VESSEL'S NAME *Stl T.S. CONTE GRANDE* Rpt. *in* No. *7869*

The remarks of the Chief Ship Surveyor are desired on this case for the consideration of the Classing Committee.

*DUCT KEEL FORWARD OF MACHINERY SPACE.*

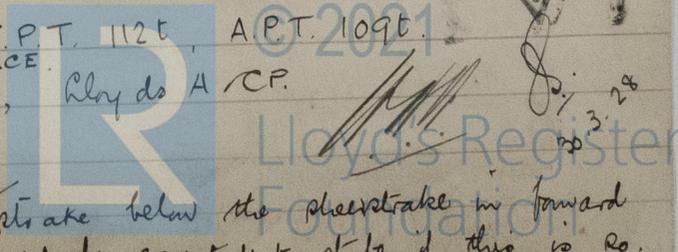
*It is concluded the thickness of the ~~plates~~ strake below the sheerstrake in forward well is as approved but the Surveyor should be requested to state if this is so.*
